### FREDERICK COUNTY HISTORIC PRESERVATION COMMISSION **STAFF REPORT** September 1, 2021

**Address:** 7127 Autumn Leaf Lane, Frederick      **Meeting Date:** September 1, 2021  
**Applicant:** Eric Gleysteen      **Report Date:** August 23, 2021  
**Case No.:** COA 21-07      **Staff:** Amanda Whitmore  
**Proposal:** Alterations to non-contributing structure

**Fig. 3: Garage structure located at the rear of the house, facing Opossumtown Pike.**

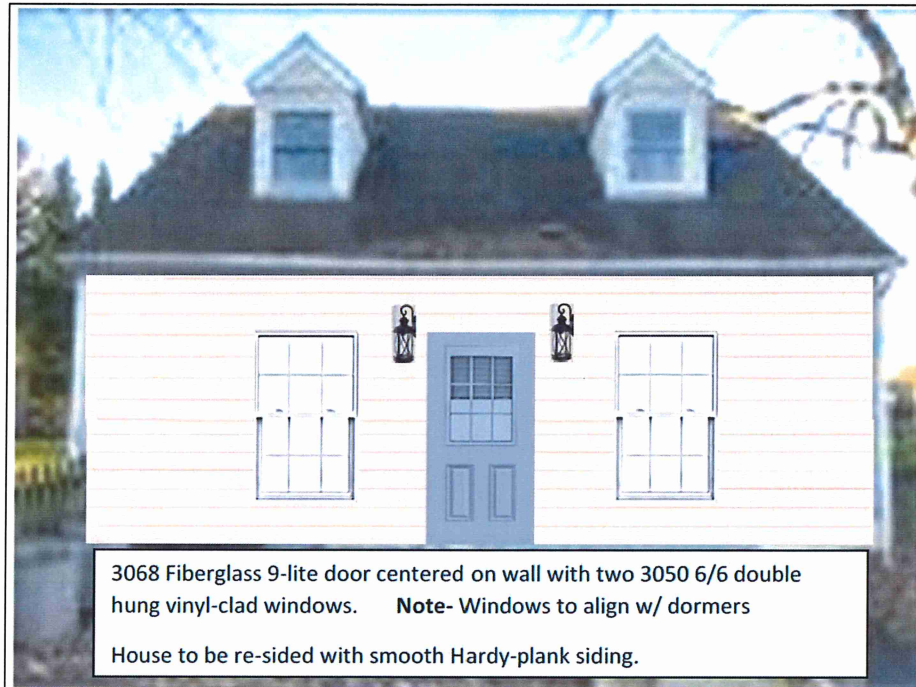
The garage structure was added to the property in the 1970s and was later converted into a living space. The one-story structure sits on a concrete block foundation under a gable roof and faces east towards Opossumtown Pike. The materials on the structure are not historic; therefore, Staff supports their removal.

**Gleysteen Recreation Room-** proposed front entry renovation

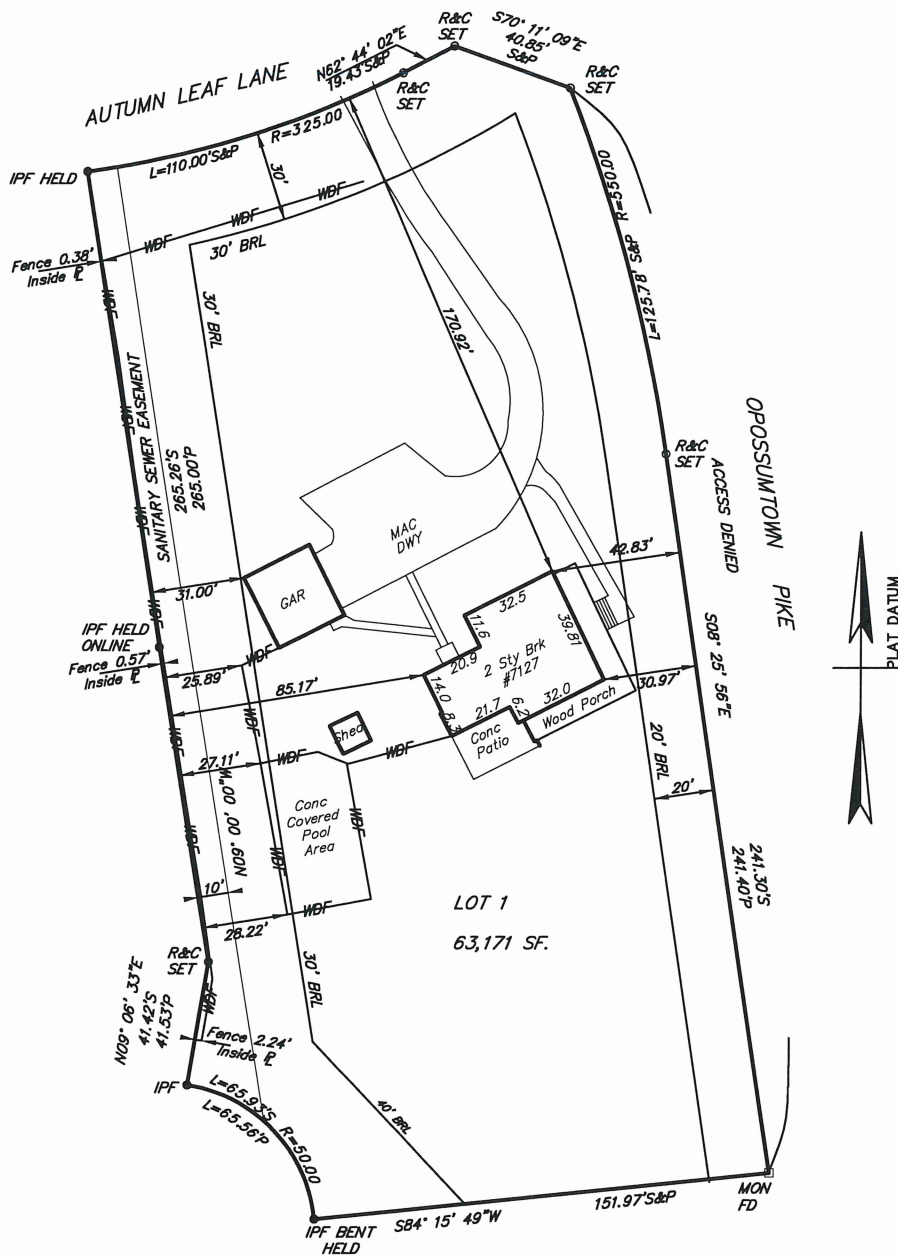
Staff finds that the change in configuration of the façade with a central entry way flanked by two windows is appropriate and compatible with the property by creating a similar order and rhythm complementary to the historic building.

The Guidelines state that vinyl and PVC materials will not be approved by the Commission. Therefore, the vinyl windows and PVC mouldings and window trim are not an acceptable material. However, the Commission may determine that a vinyl-clad wood window on a non-contributing ancillary structure is appropriate since it is not comprised entirely of vinyl. A vinyl-clad window contains wood on the interior while the exterior is covered in vinyl. Vinyl-clad windows have a longer lifespan than vinyl and are more thermally efficient. Vinyl windows can last from 10 to 15 years while a clad window can last up to 30 years. Alternatively, the Commission may determine an aluminum-clad

The window grilles complement the multi-paned windows on the historic house. However, these grilles must be adhered to the exterior of the window glazing and not be located between the glazing, per the Guidelines. Alternatively, since this is a non-contributing ancillary structure, Staff finds that one-over-one windows may be considered per the recommendations for ancillary structures in Chapter 6-C that state new outbuildings not convey a false sense of history and that new ancillary structures complement the details of the historic building but do not require them to match. Staff recommends that the grilles be simulated divided lite windows or the windows be one-over-one with no divided glass. The recommended condition, if adopted, can be confirmed by Staff upon review of permit drawings.

The replacement door is proposed to be a 9-lite fiberglass door. Chapter 6-C of the Guidelines states that the design of proposed new ancillary structures complement the massing, scale, form, orientation, materials, and details of the other historic buildings on the property. While this is not new construction, the entire façade of the structure is being re-constructed. Staff finds that the proposed door is appropriate and is complementary to the site. While Staff would prefer a door with at least four panels and fewer lites to better complement the historic building, in this instance the 9-lite door is acceptable. The structure is not historic and the door will not seriously impair the historic and architectural significance of the surrounding site.

The applicant proposes to install two carriage style lights on either side of the entryway. Staff recommends approval of the lights so long as the lights are an appropriate scale and do not mimic a specific historic style.

1. The proposed window material is entirely vinyl. This is an inappropriate material and either vinyl-clad or aluminum-clad need to be used. The recommended condition, if adopted, can be confirmed by Staff upon review of permit drawings.

2. The proposed corner mouldings and window trim are PVC. This is an inappropriate alternative material and smooth fiber cement boards need to be used. The recommended condition, if adopted, can be confirmed by Staff upon review of permit drawings.

3. Information on the location of the window grilles was not provided. Staff recommends that the grilles be simulated divided lite windows with the grilles adhered to the exterior of the window, per the Guidelines. Alternatively, Staff recommends the windows be one-over-one with no divided glass. The recommended condition, if adopted, can be confirmed by Staff upon review of permit drawings.

4. Staff recommends approval of the carriage lights with the condition that the lights are an appropriate scale and do not mimic a specific historic style.
